P. I. No. 122600, Athens-Clarke County

SR 10 Loop over SR 10/US 78 Bus/US 78

SUBJECT APPROVED REVISED PROJECT CONCEPT REPORT

REVISED PROJECT CONCEPT REPORT

figure 2: Revised Concept Sketch March, 2005

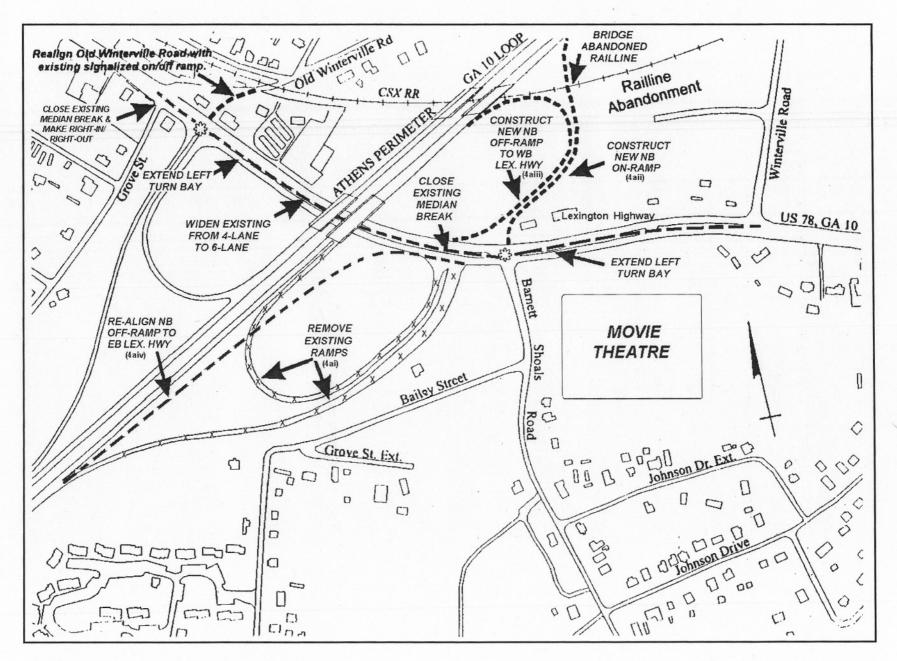
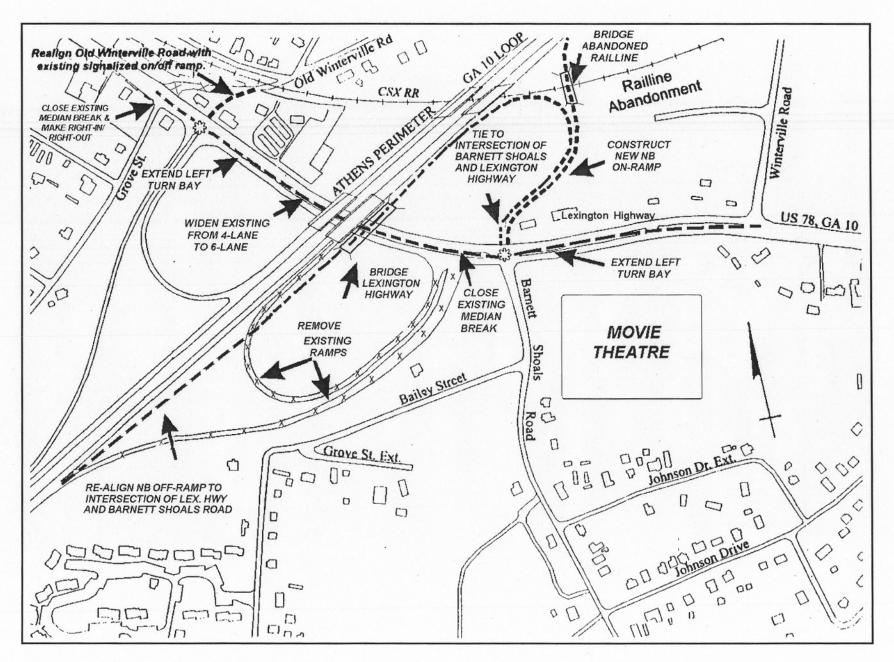
Proposed features to be revised: Due to severe congestion and increased traffic volumes along Lexington Highway through the SR10 Loop interchange, the following features need to be revised from the approved Concept Report, dated May 28, 2002:

- 1. Revise the proposed alignment of the SR10 Loop northbound on/off ramps.
- 2. Revise access control points along Lexington Highway.

- 1. Realign the northbound off-ramp from northbound SR10 Loop to begin in the southeast quadrant, bridge US78 (Lexington Highway), and loop in the northeast quadrant to align with the Barnett Shoals Road intersection at Lexington Highway.
- 2. The access control point for the existing off-ramp from northbound SR10 Loop to eastbound US78 will be converted to a two-lane exit ramp for eastbound and westbound traffic.
